# Access Compliance Report

## Public Rights-of-Way

Intersection ID: 24384	Main Street: BIRNEN_DR	Cross Street: N_VICKSBURG_PARK_CT	Location: E
ADA ID: 5D7D86F0D5ED	Ramp Type: PerpDiag	Initial Pass/Fail: Fail	Overall Compliance: No
Severity Score: 26.25			
Codes/Mitigation Info/Possible Solution		Field Measurements/Component Compliance

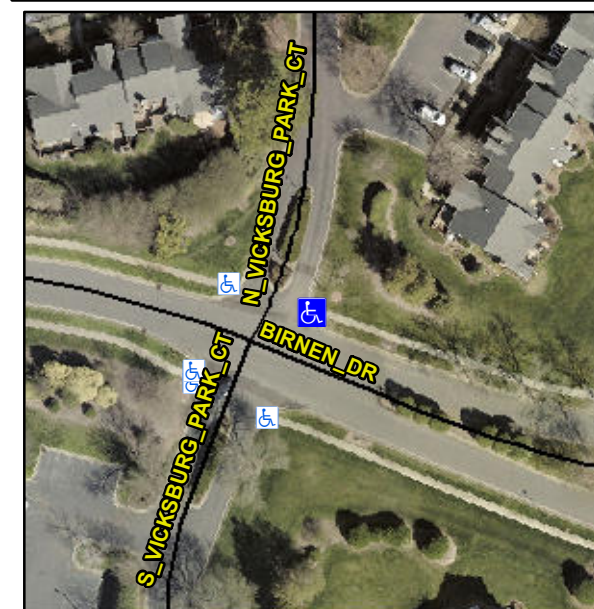
**Remove & Replace Curb Ramp With Two New Directional Ramps or Equivalent.**

**R304.2.2, R304.5.3**

Compliance	Description	Data	Compliance	Description	Data
N/A	Ramp Length (in)	41.5	No	Ramp Slope (%)	13.0
Yes	Ramp Width (in)	48.0	No	Ramp XSlope (%)	4.3
N/A	Flare Type LT	N/A	N/A	Flare Type RT	N/A
N/A	Flare Slope LT (%)	N/A	N/A	Flare Slope RT (%)	N/A
N/A	Flare Traversable LT?	N/A	N/A	Flare Traversable RT?	N/A
N/A	Landing Length (in)	N/A	N/A	DWS Provided?	N/A
N/A	Landing Width (in)	N/A	N/A	DWS Contrast?	N/A
N/A	Landing Slope (%)	N/A	N/A	DWS Length (in)	N/A
N/A	Landing X Slope (%)	N/A	N/A	DWS Full Width?	N/A
N/A	Landing Curb? (Y/N)	N/A	N/A	DWS Offset (in)	N/A
N/A	Shared Landing?	N/A			
N/A	Gutter Ponding?	N/A	N/A	Gutter Slope (%)	N/A
N/A	Gutter Lip Ht (in)	N/A	N/A	Gutter X Slope (%)	N/A
N/A	Painted X Walk1?	No	N/A	Painted X Walk2?	No
	X Walk 1 Direction	To NW		X Walk 2 Direction	To SW
N/A	X Walk 1 Width (in)	N/A	N/A	X Walk 2 Width (in)	N/A
	X Walk 1 Slope (%)	1.5		X Walk 2 Slope (%)	0.0
	X Walk 1 X Slope (%)	0.5		X Walk 2 X Slope (%)	1.2
